SECOND FLOOR PLAN OF PROPOSED REPAIR / REINFORCEMENT AND
PROPOSED REPLACEMENT DORMER
SCALE 1:50

PLANNING DRAWINGS

DESCRIPTION	
SECOND FLOOR PLAN AS PROPOSED	
LOCATION NURSTEAD HALL	DRG No. PP-18Q-05
NURSTEAD LANE	REV B
LONGFIELD HILL	SCALE: 1:50 @ A1
KENT, DA3 7AN	DATE: MAY 2023
CLIENT MR & MRS HOLM	SIG RP

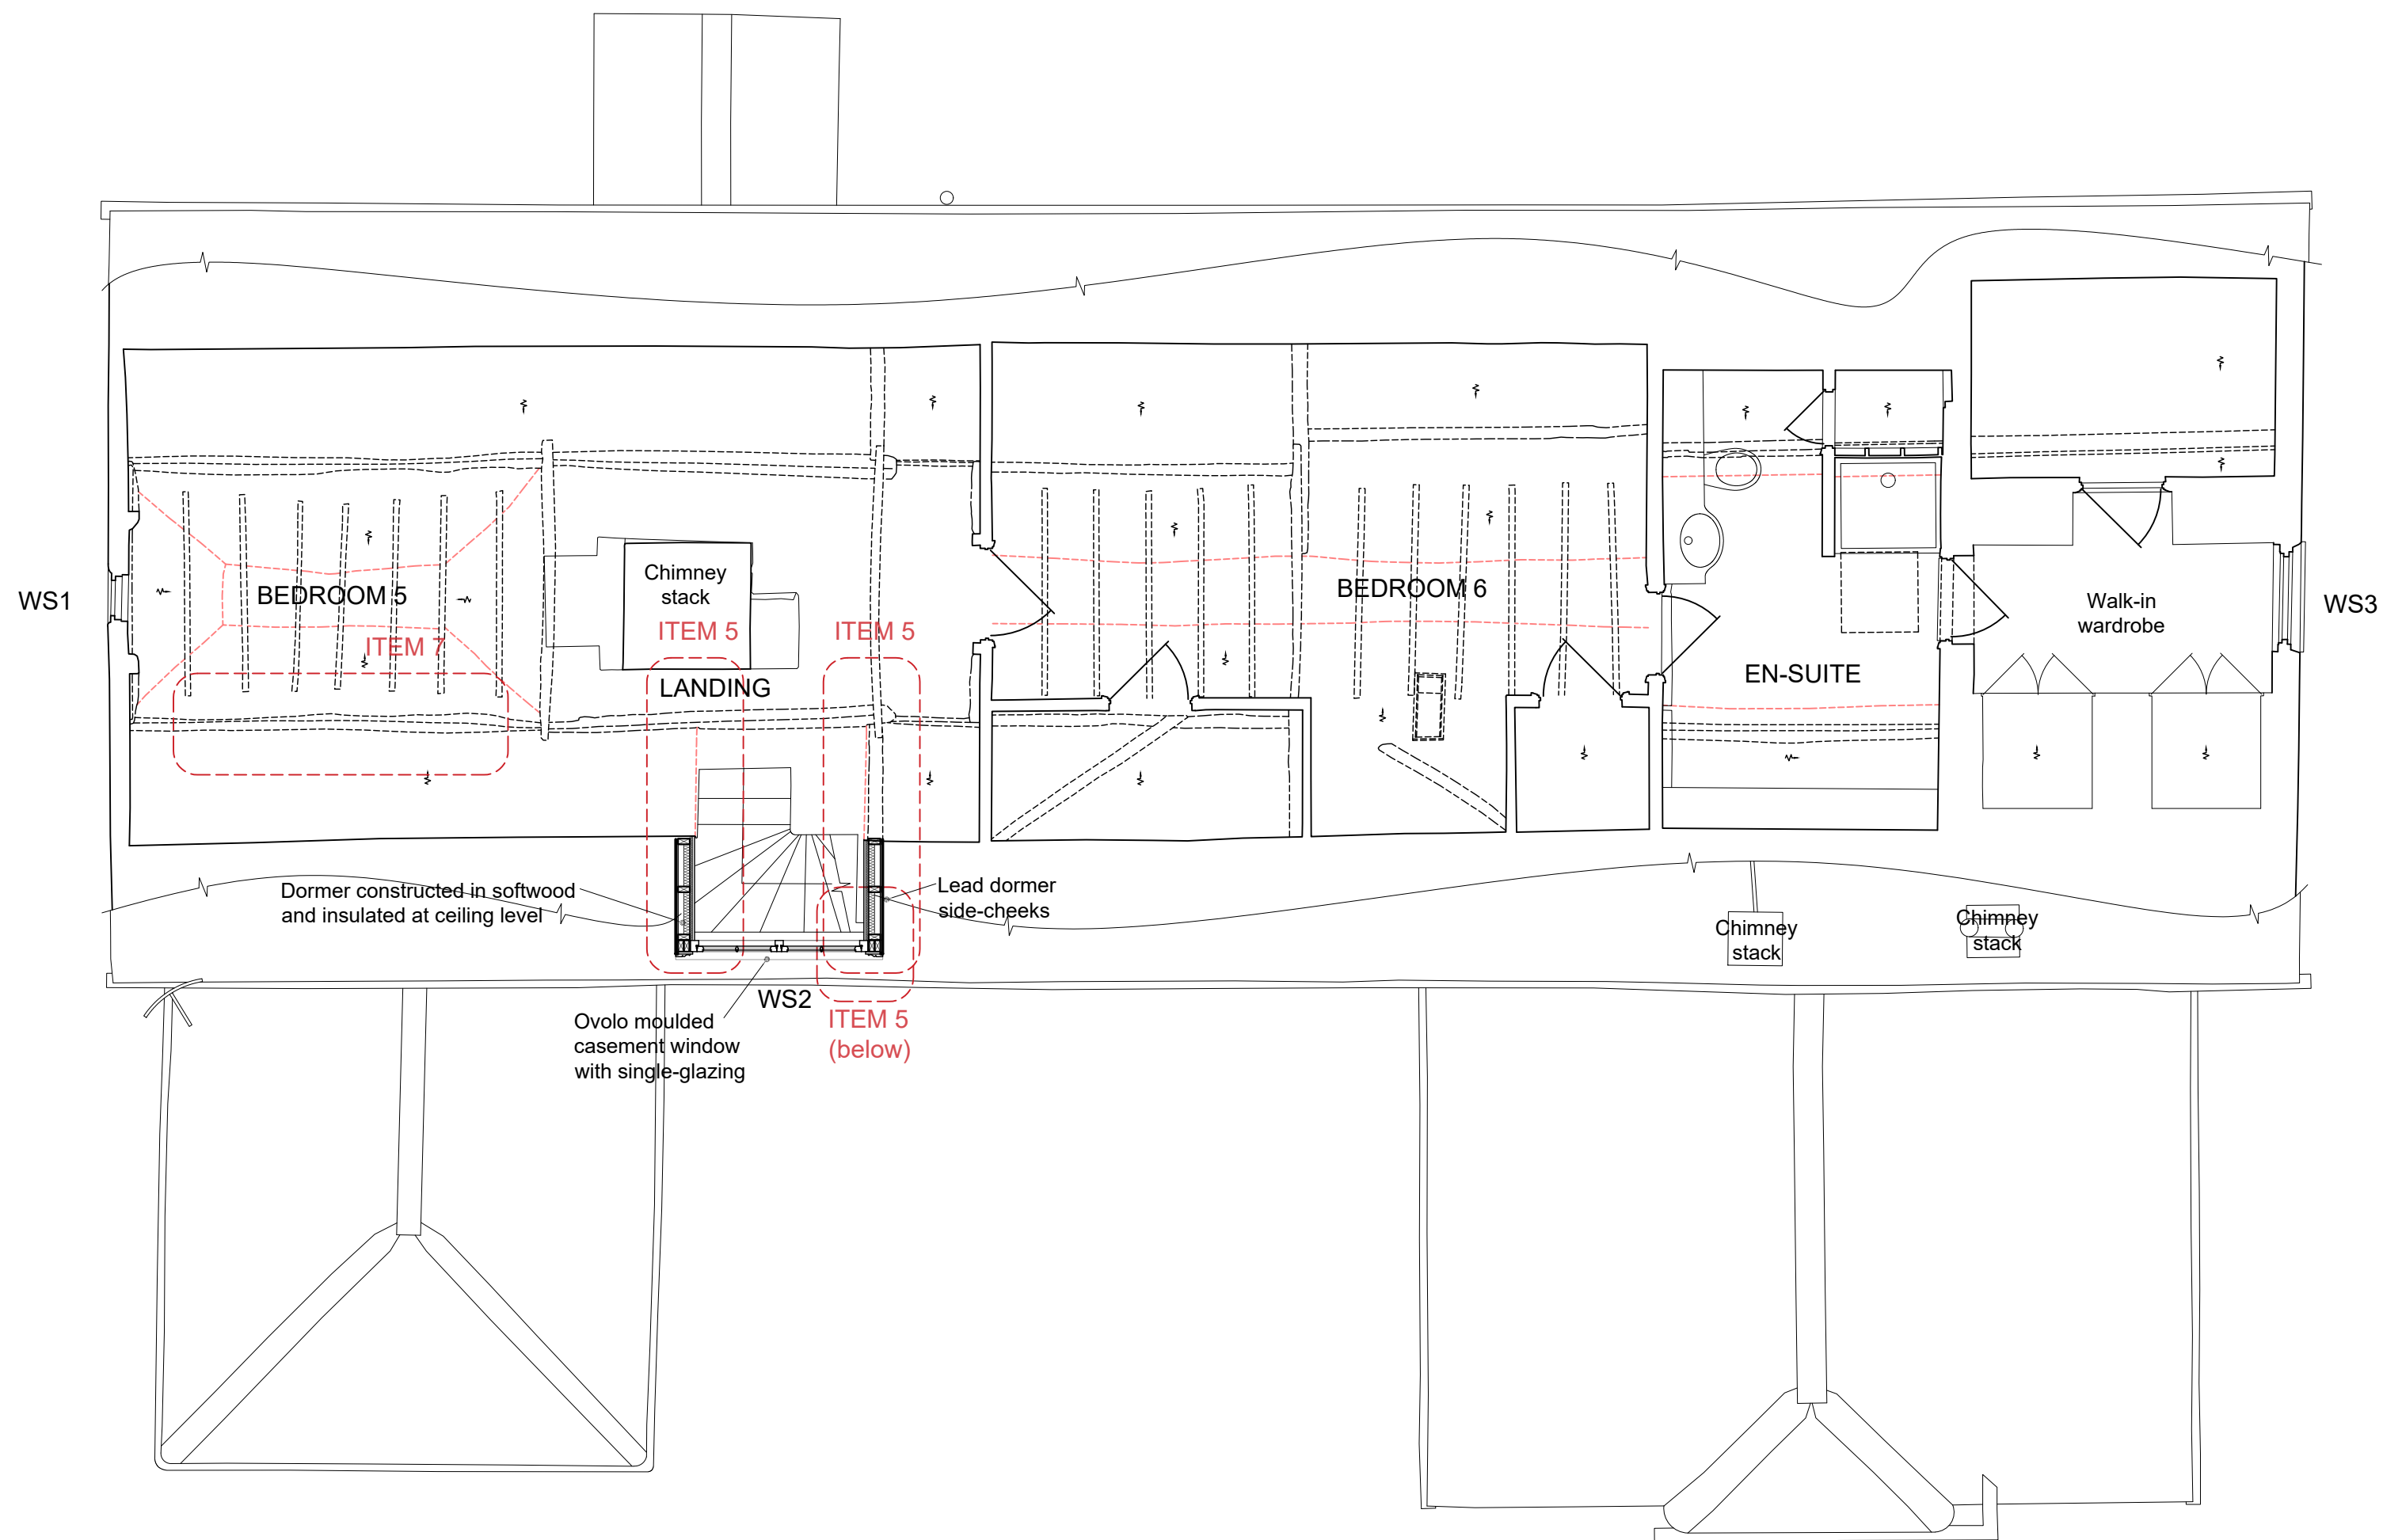
Rev.B 05-09-2023 - Dormer design altered and notes added to paint steelwork black, to suit conservation officer's comments

Replacement dormer construction and WS2
Replacement dormer to be constructed from treated softwood.
The roof will be a flat roof construction with a fall towards the front to suit lead sheet with leaded rolls. The roof is proposed to be insulated at ceiling level and the walls insulated between studs and over the inside of the studs. Both the ceiling and walls will be plaster-boarded and skimmed with gypsum plaster internally. The dormer cheeks are proposed to be clad in lead sheet.
WS2 is proposed to be constructed in hardwood with single-glazing between glazing bars, painted internally and externally with Superdec paint or similar breathable paint.

Item 7 – Over deflected Roof Purlin with fracture to West End of Building
This purlin is located within the second-floor attic room of the property. The purlin spans approximately 3.4metres between the west elevation gable wall and a large collar. The purlin has a fracture along its length. Although the purlin is over-deflected, collars are present at a slightly higher level which will relieve the purlin of some weight. Due to the fracture, we would however recommend that a steel plate (8mm thick), profiled to suit the shape of the purlin is added and fixed alongside with coach screws at 400mm centres in order to regain its integrity. Note!!steelwork to be painted black.
